29 October 2021

1.1 My name is Sarah Duffell; I am employed by WCC in the position of Senior Urban Design Advisor in the Urban Design team. My main task in this role is to undertake urban design assessment of resource consent applications against the design-related provisions of the District Plan.

2.1 This proposal is described in the application as follows:

"The proposal is the partial demolition of elements of the existing building and the construction of a hotel building behind the existing main façade of the existing building ...

4.3.5 The relationship between the development site and the neighbouring building in Drummond Street can be seen in this cross-section – noting that the development is proposed to exceed the permitted height limit by a little over two storeys:

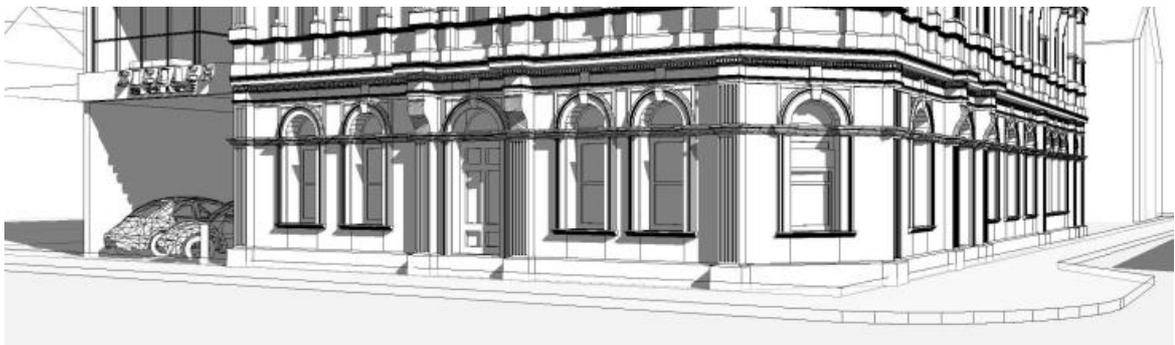
4.3.7 However, the building is still over-height, and a preferred outcome (taking into account the scale and form of the heritage building at the base of the development) would be to permit the

minimum number of additional storeys above the original building as required to secure the project. I note that the Applicant's position is that it is not economically viable to proceed with a development on this site that does not provide approximately 2,300m² of floor area, however the figures that are presented in the application are not accompanied by sufficient explanation and have not been peer reviewed. The Urban Design conclusion is that some additional height could be most likely be permitted on this site as a response to context but this would need to be subject to achieving a proven rationale along with a good quality design outcome for both the site and with respect for the future of the listed building. At this point, that outcome has not been achieved.

From application, sheet A-200

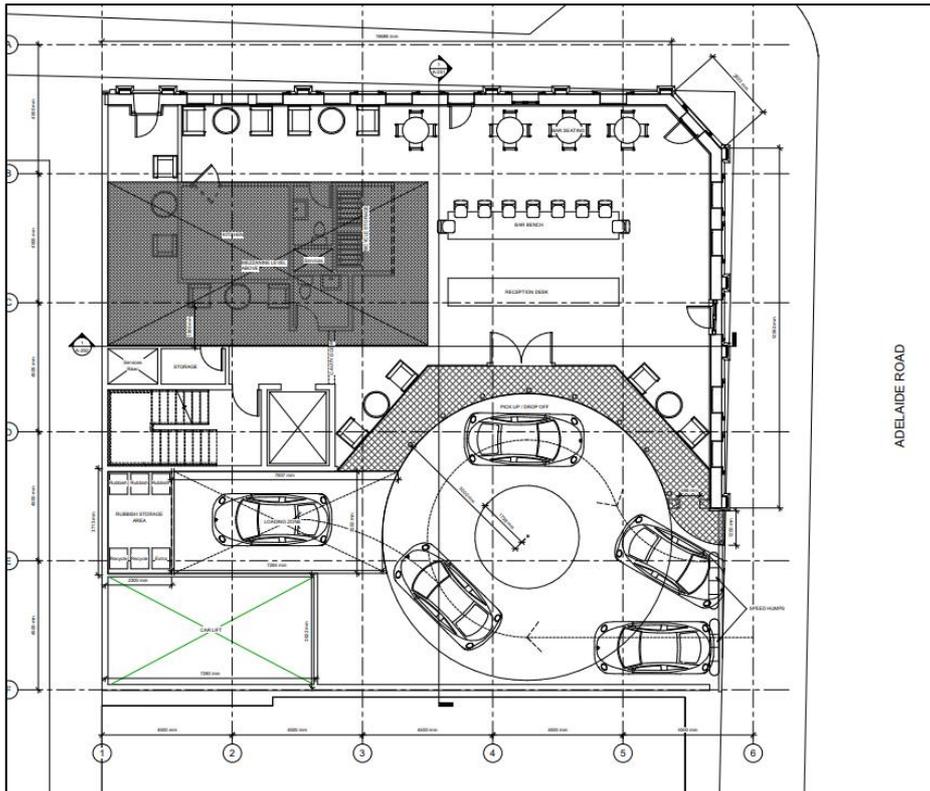
- 4.4.4 The application is contradictory on the matter of the opening on the site's north-east corner. The floor plans show a single door, while the elevations show replacement with a window. On the ground floor, the floor plan also appears to prioritise entry to the hotel via car, with an internal drop-off area with double doors and a reception desk facing these doors. The other three (four?) doors around the ground floor perimeter are shown as openable single doors, and there is a double-width undercroft vehicle crossing onto Adelaide Road.

Ground floor plan, from application sheet A-101

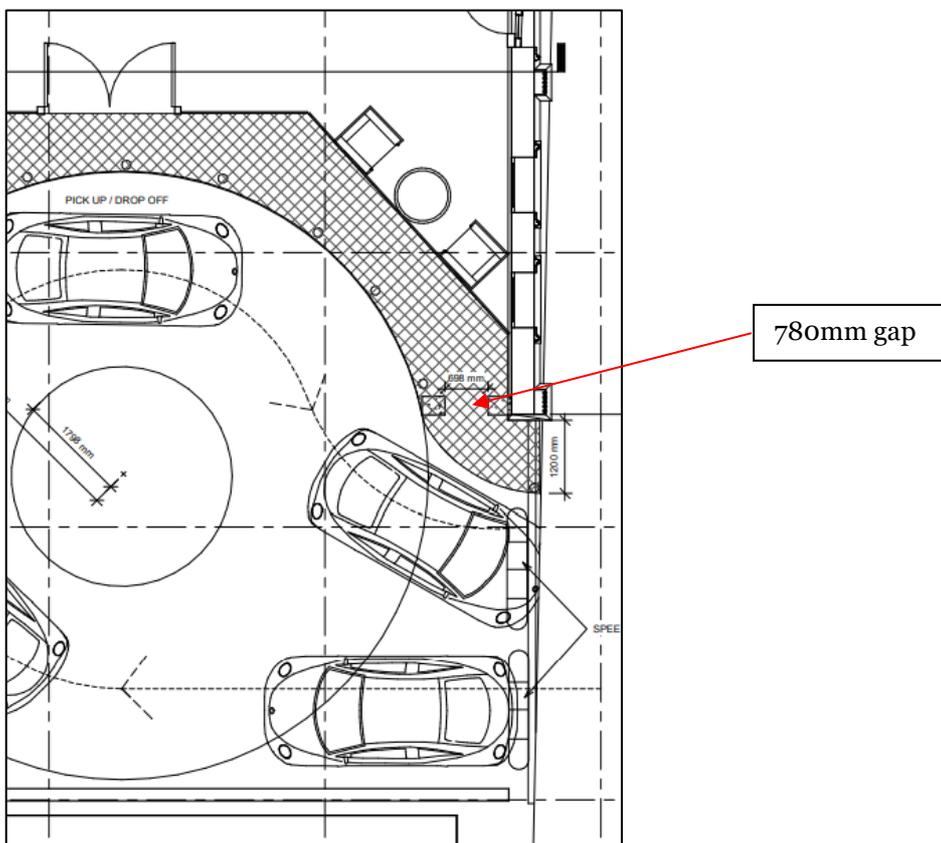
4.4.5 Additionally there appears to be a pedestrian pathway of just over a metre wide beside the car entry, however this becomes constricted to 780mm wide just inside the site edge.

The minimum door width accessible for a wheelchair user is **760 mm**, but a space that is **810 mm** wide is easier for a wheelchair to go through. At a point where accessible access to the facility could be provided, the constricted width makes this difficult. Providing level conditions that aren't easily accessible is an urban design outcome that should be addressed.

- 4.4.6 As a result of the proposed ground floor layout the '*classy hotel entrance*' referred to in the design statement is unfortunately buried within the floor plan and will be generally invisible from the public spaces adjoining the site. The main advantage of the ground floor layout will be gained by arriving by car, which misses an opportunity to celebrate the building's heritage and original entries.

- 4.4.7 These ground floor conditions may also lead to confusion of entries, and the introduction of a vehicle crossing over a pedestrian footpath that will only get busier over time is an unsafe outcome. There are three valid points to note when considering current and future access/arrival conditions for the building. These are:

- 4.4.11 To improve the urban design outcomes the scheme would ideally be amended to:
- Reduce the dominance of the Adelaide Road vehicle access in favour of kerbside arrival for visitors on Drummond Street

- Engage the main entry to the hotel with an adjacent street rather than with a visually hidden internal space.
 - Utilise and celebrate more the original doorway(s) of the hotel building. Use the central door on Drummond Street as the hotel’s ‘front door’.

- Ensure fully accessible conditions.
 - If possible, delete the basement parking area. Only provide access onto Adelaide Road if required for loading and/or access to the car stacker.
